HISTORIC LANDMARK COMMISSION STAFF REPORT

Peery Hotel

PLNHLC2008-00674 Rebuild Historic Entry Canopy

April 1, 2009

SITE PLAN
SCALE 1/8" = 1'-0"

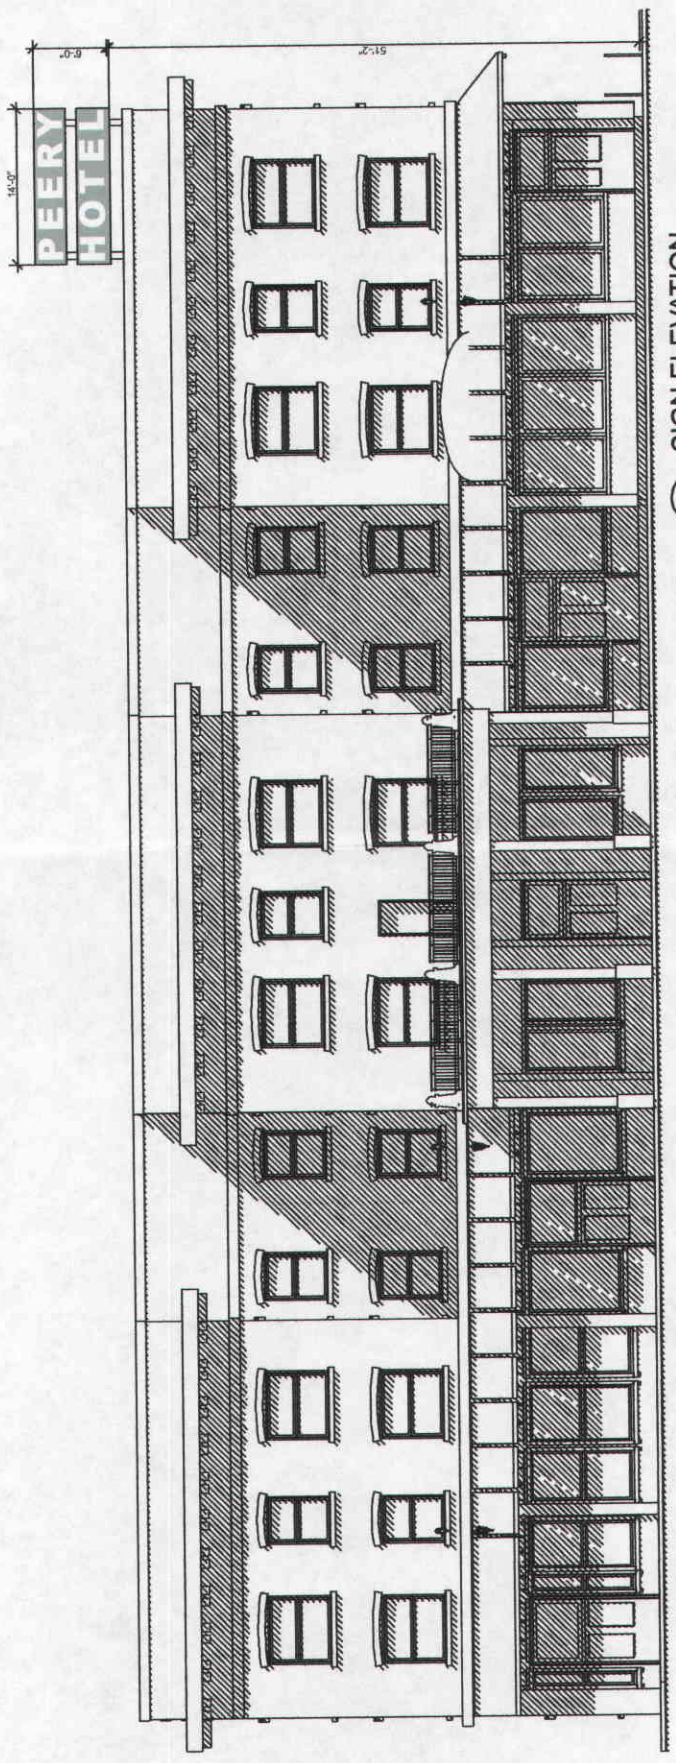
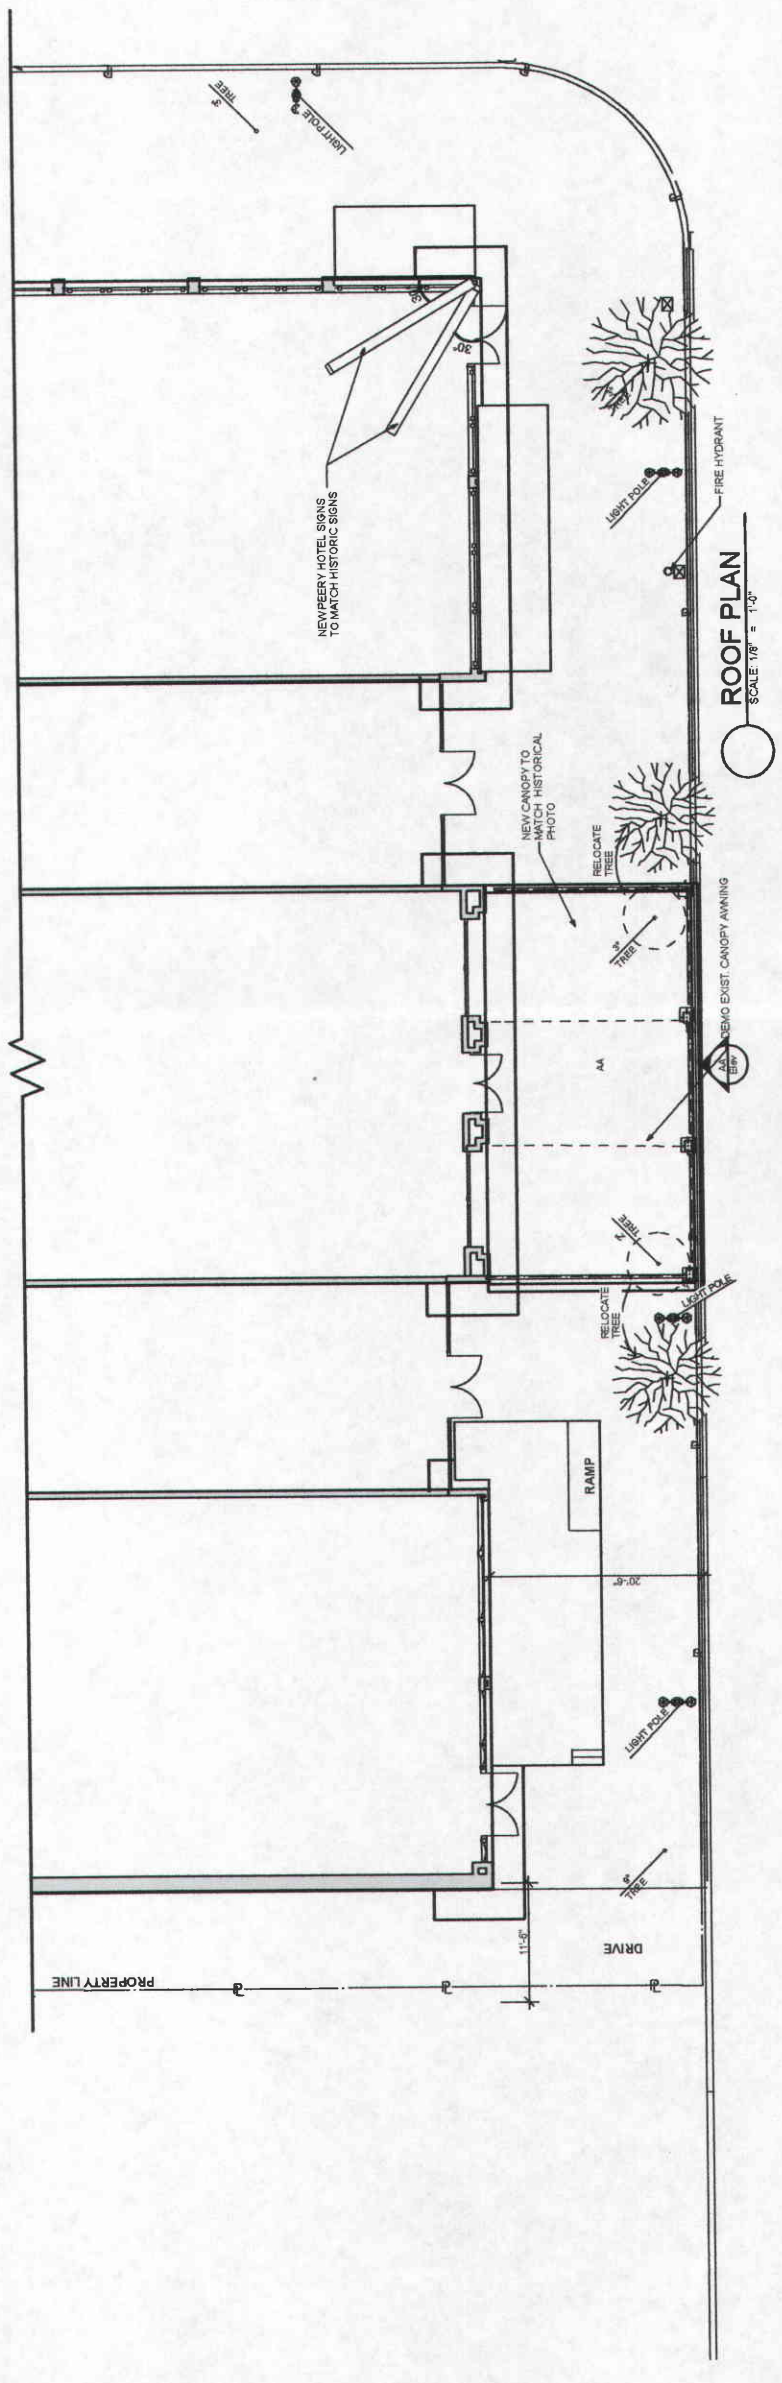
The site plan needs to be revised to show the property line at the face of the building, not at the back of curb.

The pedestrian corridor / sidewalk needs to maintain a clear 6' width in retail areas, 8' wide in CBD area & 10' wide on Main Street in the CBD area. The submittal does not indicate the post setback from the curb face or the clearance between the post and building face.

The street light location needs to be detailed for review by Michael Barry, street lighting coordinator.
